Planning Commission Meeting Packet

June 13, 2017

a. Public Hearing – SP 16-09/ CUP 16-04 Oregon Street Townhomes

**Oregon Street Townhomes Site Plan and Conditional Use Permit
SP 16-09/CUP 16-04**

JOB NUMBER: 5416
SHEET: 04

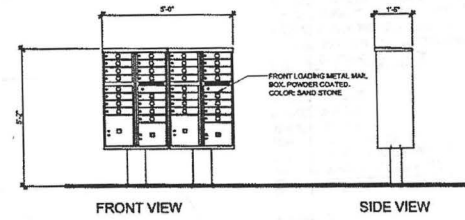
STAFF ANALYSIS: As shown on the Preliminary Site Plan (Exhibit A, Sheet 04), two vehicular access points are provided via SW Oregon Street. A private access drive connects the two access points through the site. Vehicular access is provided to the rear of Buildings 1-4, which front onto SW Oregon Street, and to the front of Buildings 5 and 6 which are located to the rear of Buildings 1-4. No garages face a public street and no alleys are proposed.

STAFF ANALYSIS: As shown on the Preliminary Site Plan (Exhibit A, Sheet 04), a new 24-foot wide private driveway though the site will provide access to all units and guest parking located on site. This driveway will provide access to SW Oregon Street at the site's north and south ends. The application does not propose any new public street construction.

ANALYSIS: No mechanical equipment, outdoor storage or service or delivery areas are proposed on the Preliminary Site Plan (Exhibit A, Sheet 04). The applicant has indicated via telephone calls with staff that ground mounted air conditioning units will be installed. Revised plans will need to show adequate screening from all public streets.

STAFF ANALYSIS: The Site Plan (Exhibit A, Sheet 04) shows 3 separate pedestrian connections between the project's SW Oregon Street frontage and the interior of the site. These pedestrian connections will ensure safe and convenient access between residences and commercial uses and other activities in Old Town Sherwood.
